RE: McCumber Hill Pit, File No. M-2000-151, Technical Revision (TR-2), Adequacy Review #1

.kmz file submitted to the Division on January 10, 2024
by Jodi Schreiber as part of TR-2 for the McCumber Hill Pit,
File No. M-2000-151

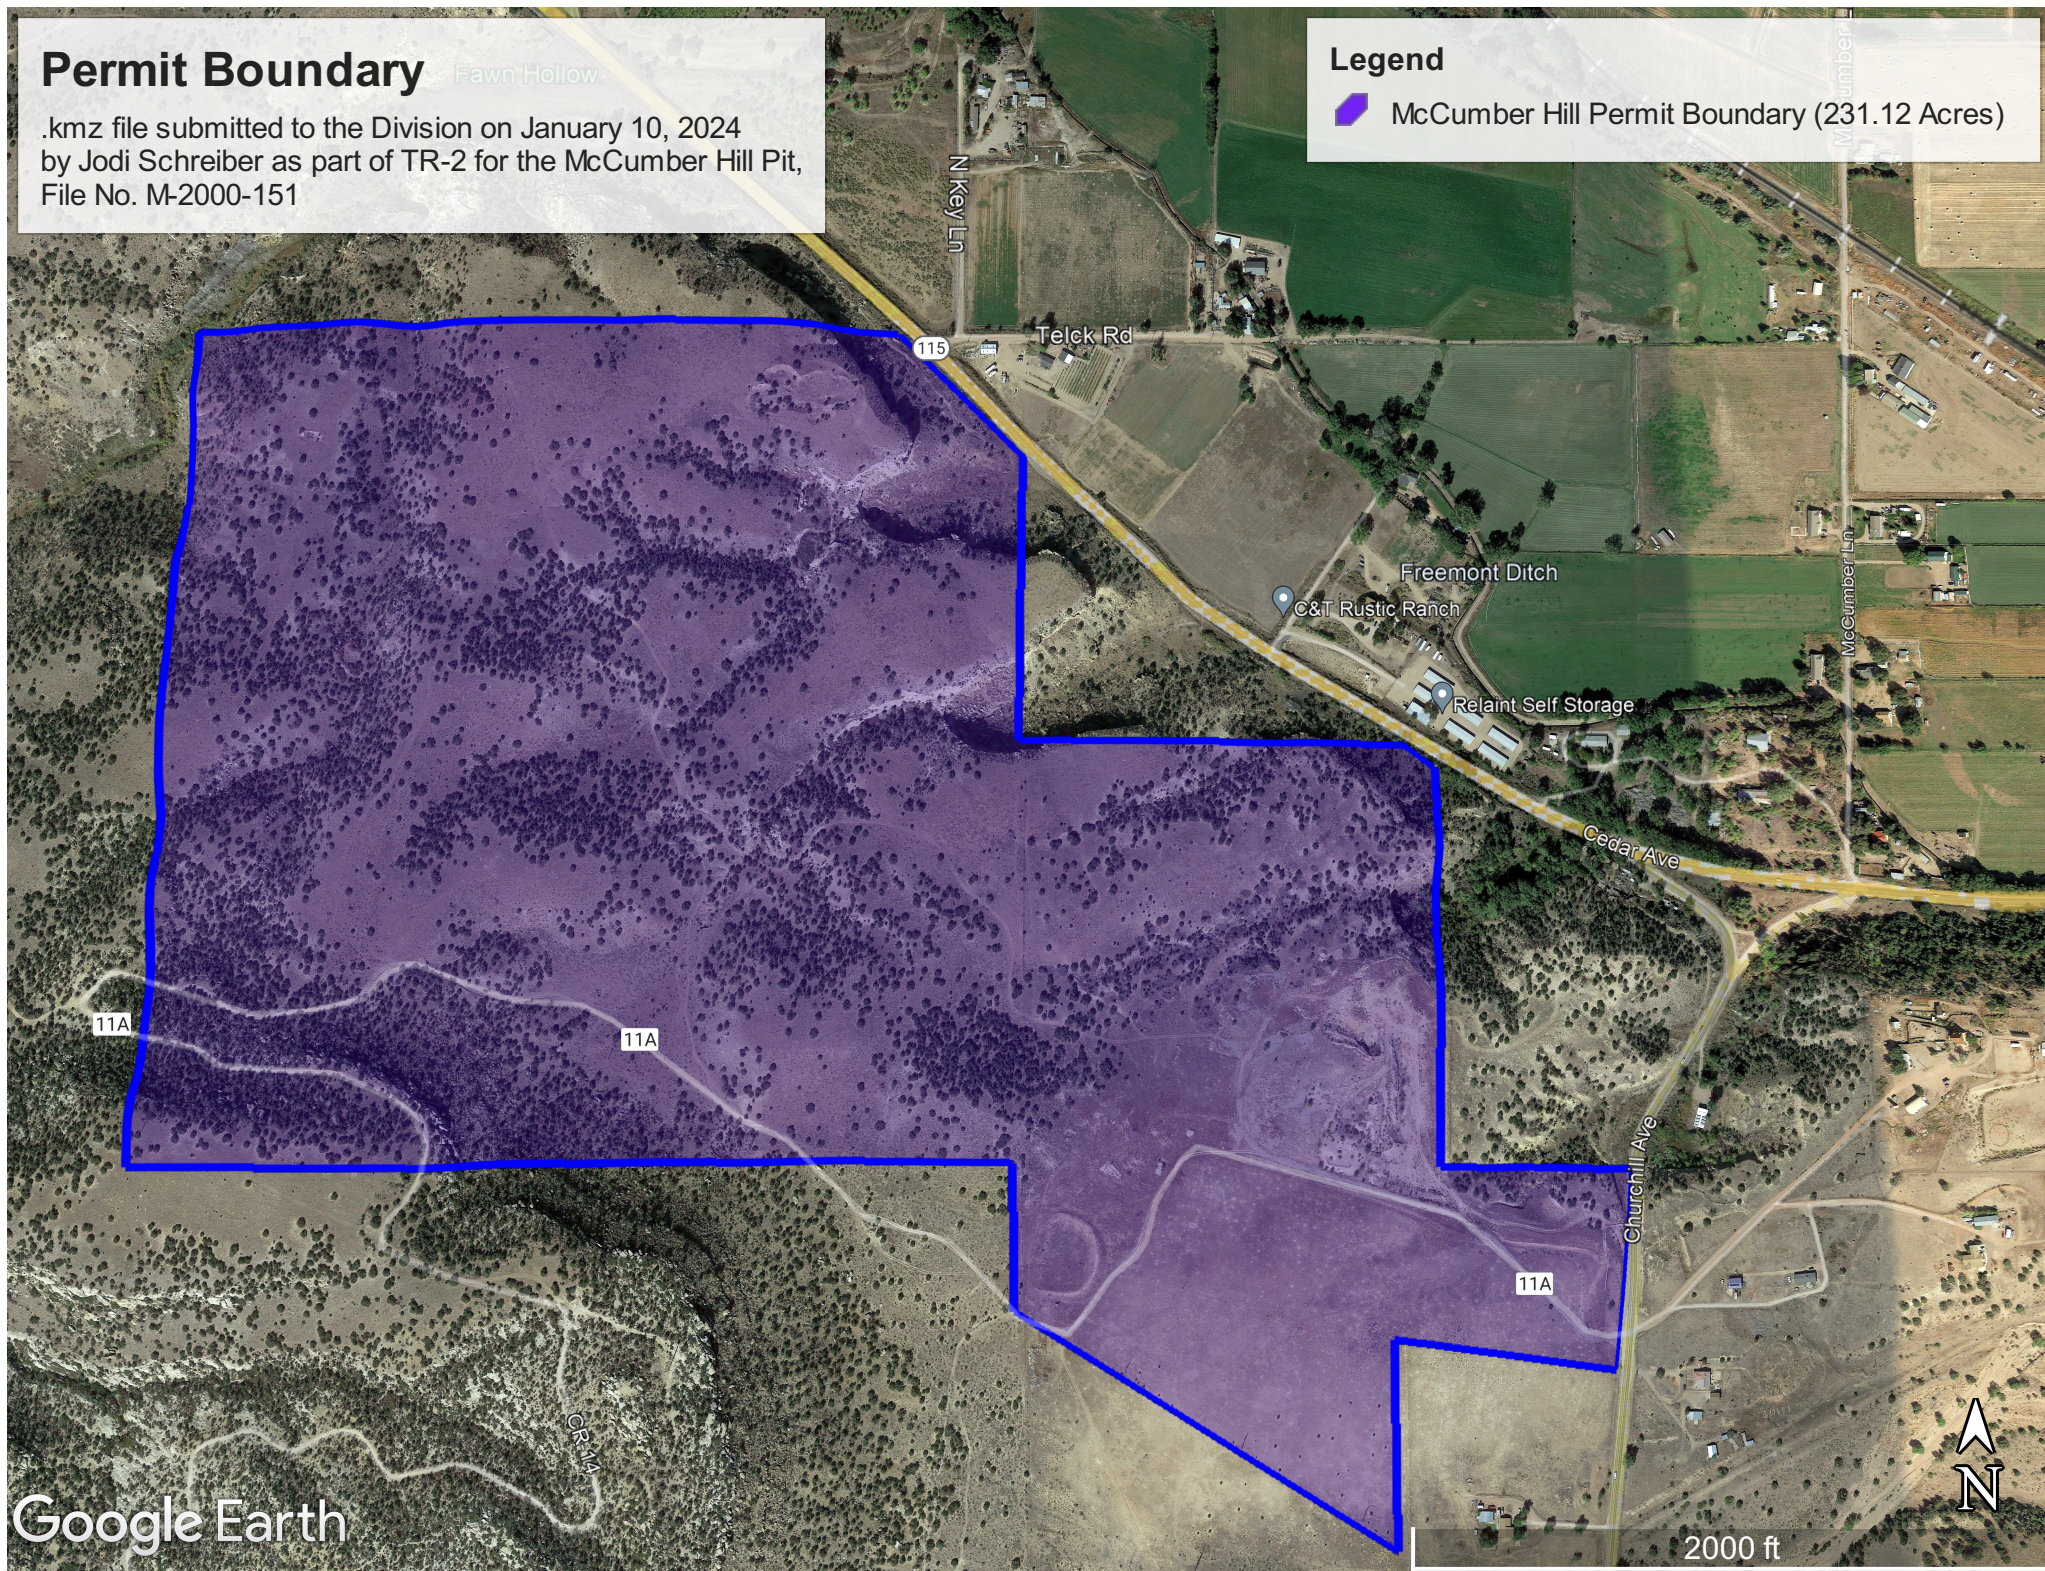
3. The Division acknowledges receipt of a .kmz file outlining the current permit boundary for the McCumber Hill Pit. This submission has been documented as seen on the pages attached below and include a table of coordinates for the vertices of the permit boundary polygon. The Division requests that additional .kmz files outlining the following boundaries be submitted to the Division:

- a. Affected area boundary polygon (Note: this is not meant to be an outline of the area currently affected by mining operations, but rather the boundary of all areas to be affected throughout the life of the mine. According to the site's mining plan maps, this boundary is not currently coincident with the permit boundary.)

- b. Phase 1 boundary polygon
